SECTION: 307-01

Rattling/Vibrating Noise From Underneath The Vehicle When Driving On An Uneven Road Surface

AFFECTED VEHICLE RANGE:

E175513

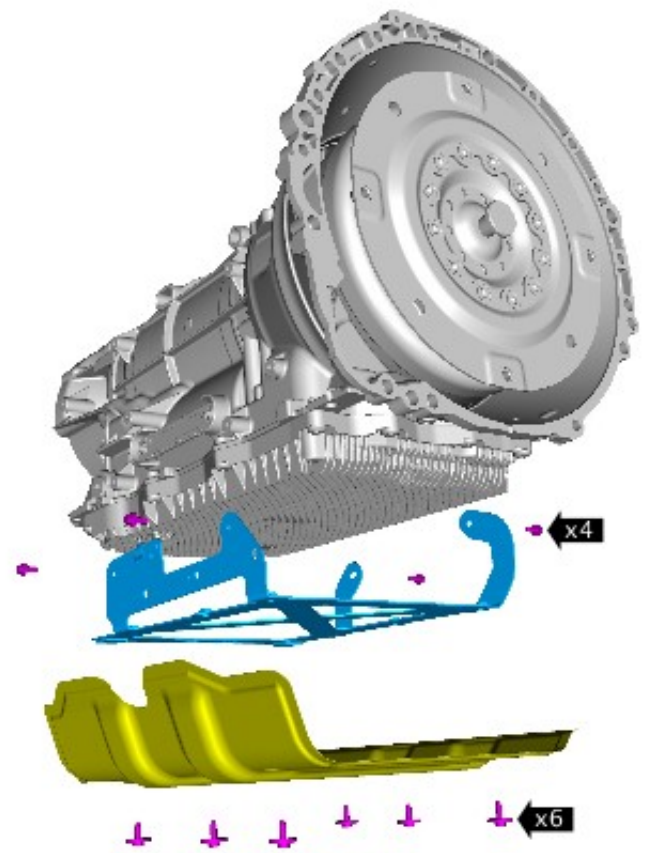
2 Remove the transmission heat shield mounting bracket.

- Torque: 9 Nm

3To install the new transmission heat shield mounting bracket, reverse the removal procedure.
